Access Compliance Report Public Rights-of-Way (Curb Ramps)

Main Street: LONE_OAK_CIR Cross Street: SLEEPY_HOLLOW_LN Location: S

ADA ID: RPRK211021135340 Ramp Type: Type 4 - Parallel Initial Pass/Fail: Fail Overall Compliance: No Severity Score: 15

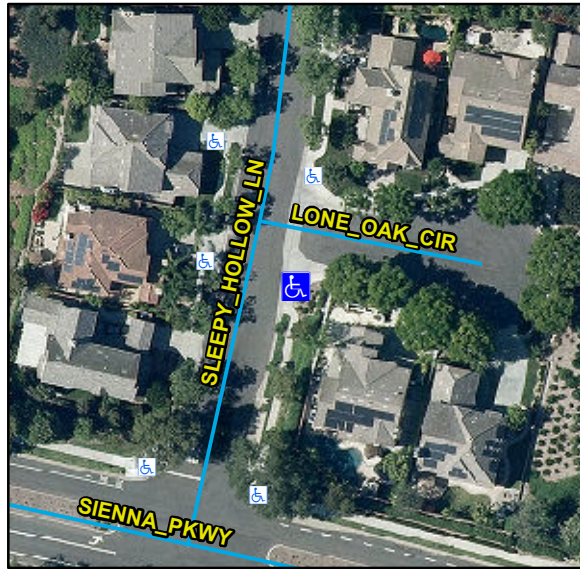
Compliance	Description	Data	Compliance	Description	Data
N/A	Ramp Length LT (in)	113	N/A	Ramp Length RT (in)	116
Yes	Ramp Width LT (in)	53	Yes	Ramp Width RT (in)	54
No	Ramp Run Slope LT (%)	11.1	Yes	Ramp Run Slope RT (%)	0.3
Yes	Ramp Cross Slope LT (%)	1.4	Yes	Ramp Cross Slope RT (%)	0.2
N/A	Landing Present	N/A	N/A	DWS Provided	N/A
N/A	Landing Length (in)	N/A	N/A	DWS Contrast	N/A
N/A	Landing Width (in)	N/A	N/A	DWS Length (in)	N/A
N/A	Landing Run Slope (%)	N/A	N/A	DWS Full Width	N/A
N/A	Landing Cross Slope (%)	N/A		DWS Offset Type	N/A
N/A	Landing Movement Obstructed?	N/A	N/A	DWS Offset Left (in)	N/A
	Landing Movement Type	N/A	N/A	DWS Offset Right (in)	N/A
N/A	Landing Shared	N/A			
N/A	Clear Space	Yes			
N/A	Clear Space To Crosswalk (in)	N/A			
N/A	Marked Crosswalk 1	No	N/A	Marked Crosswalk 2	No
	Crossing 1 Direction	NE		Crossing 2 Direction	NW
N/A	Marked Crosswalk 1 Width (in)	N/A		Marked Crosswalk 2 Width (in)	N/A

Remove & Replace Curb Ramp With Two New Directional Ramps or Equivalent.
